SUBJECT: Resolution to Approve the Germantown Sector Plan

Subject: Approval of Planning Board Draft Sector Plan for the Germantown Employment Area

The Planning Board Draft Sector Plan for the Germantown Employment Area, dated February 2009, is approved with revisions. County Council revisions to the Planning Board Draft Sector Plan for the Germantown Employment Area are identified below. Deletions to the text of the Plan are indicated by [brackets], additions by underscoring.

Germantown Town Center District

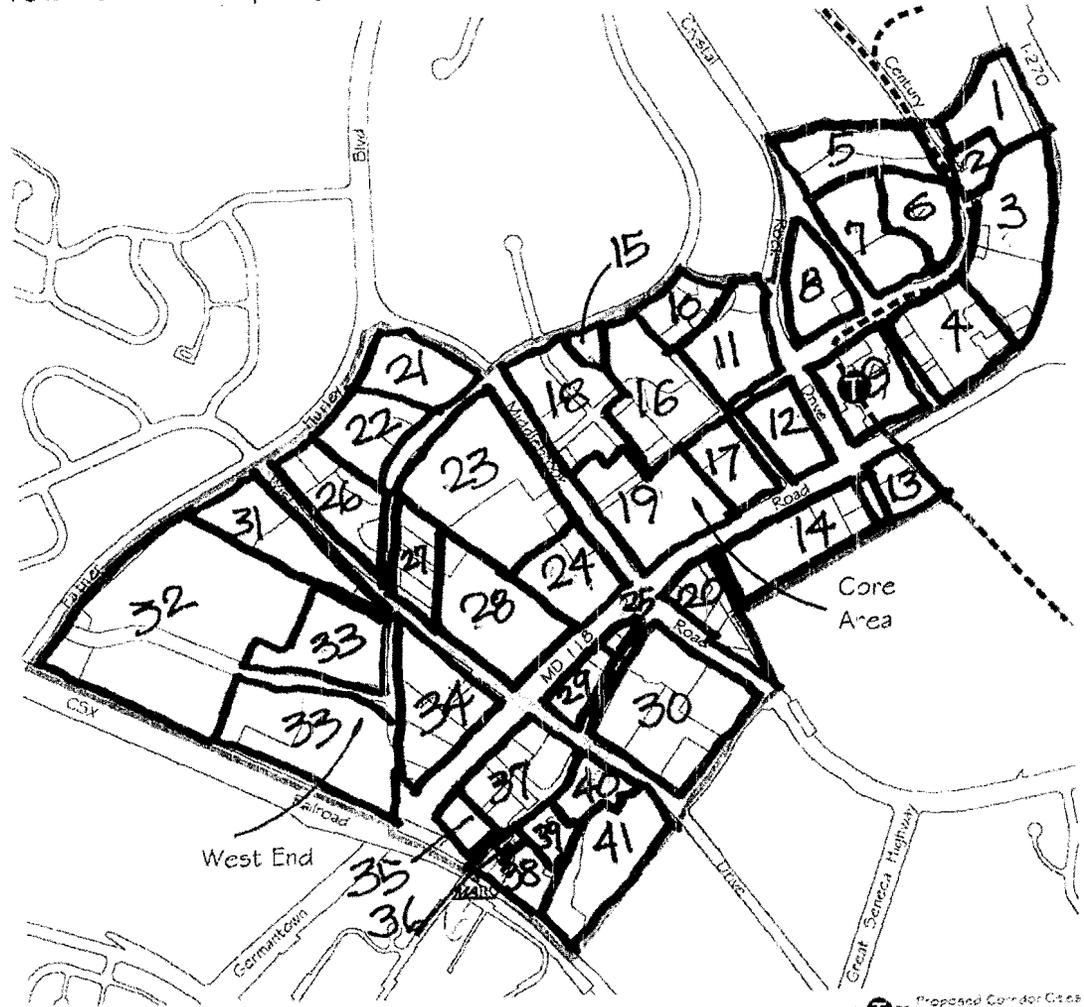
Planning Department Staff have renumbered the properties in Town Center so that all properties considered by the Council are now numbered. A chart which indicates the changes in numbers appears on © 31 and a map of the newly numbered properties in on © 32. Attached on © 33 to 37 is a memorandum from Planning Department Staff addressing the following issues:

Germantown MP PAMR Chart - Alt 2c

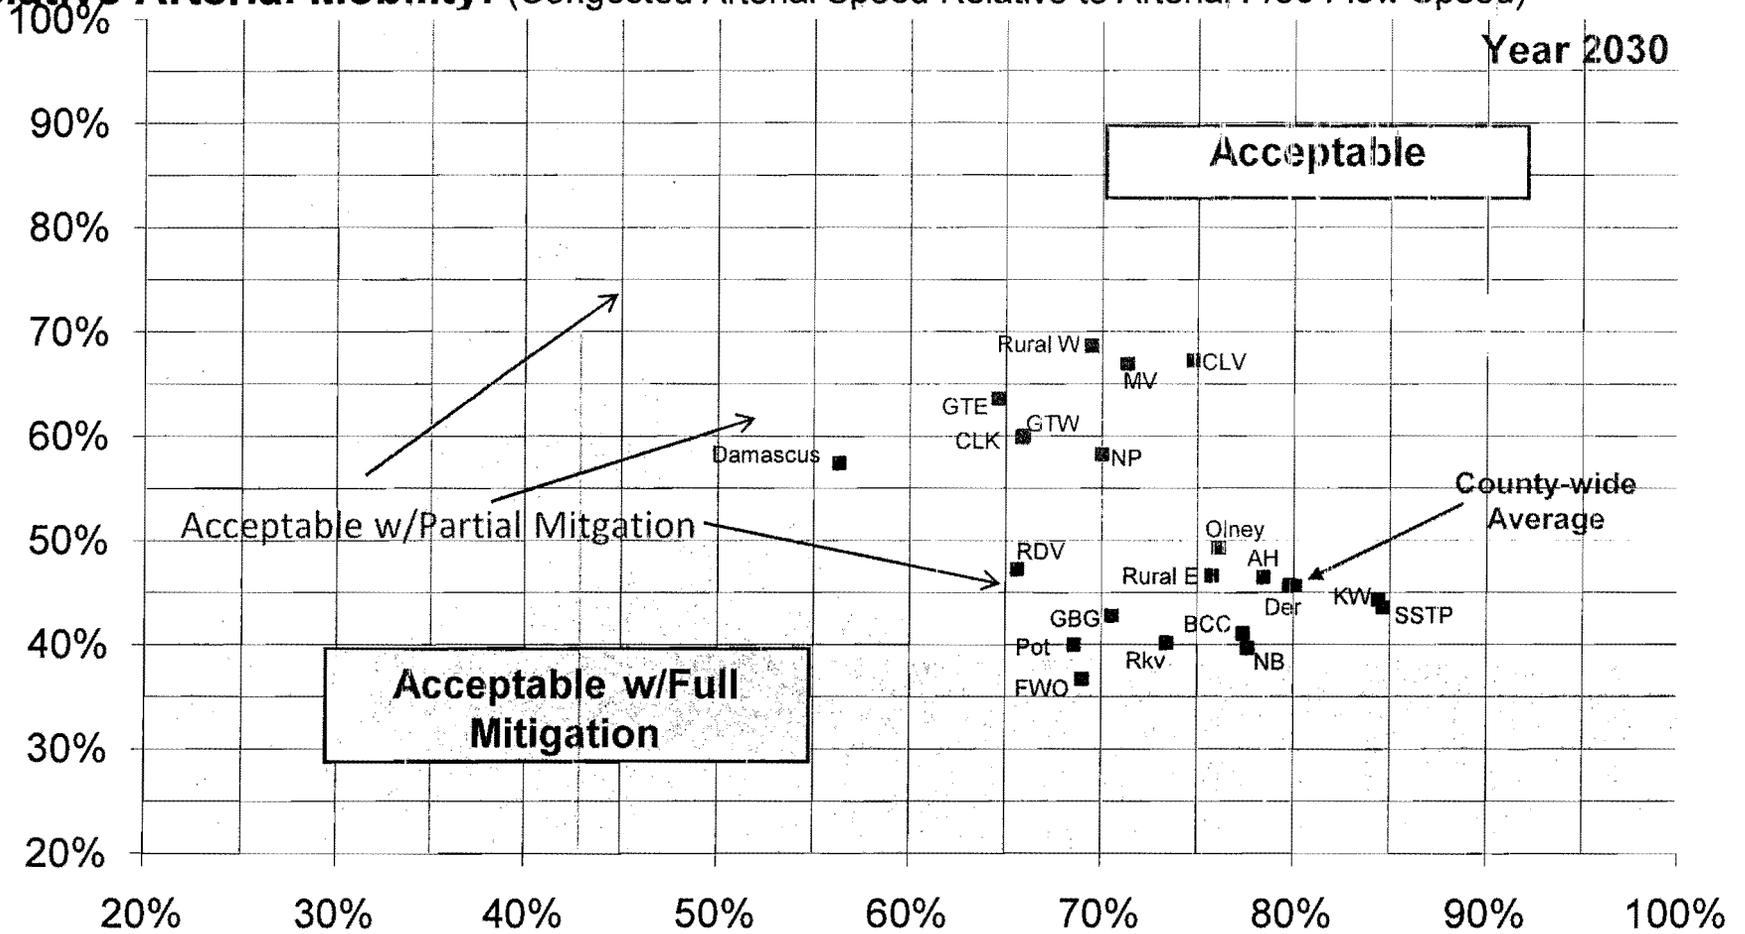
- Planning Department Staff reran the transportation model with all the changes approved by the Council. The result indicates that the land use and transportation are still in balance.
- The Planning Department recommends the rezoning of a small C-1 property so as not to make it a non-conforming use. This is a substantive change from the Council action thus far, but one that Council staff supports. The resolution before you includes the Planning Department recommended change (see lines 1161 to 1162).
- The Planning Department has indicated that they will have comments regarding the language at the end of the resolution about accounting for previously dedicated public use/open space (see lines 1312 to 1317).
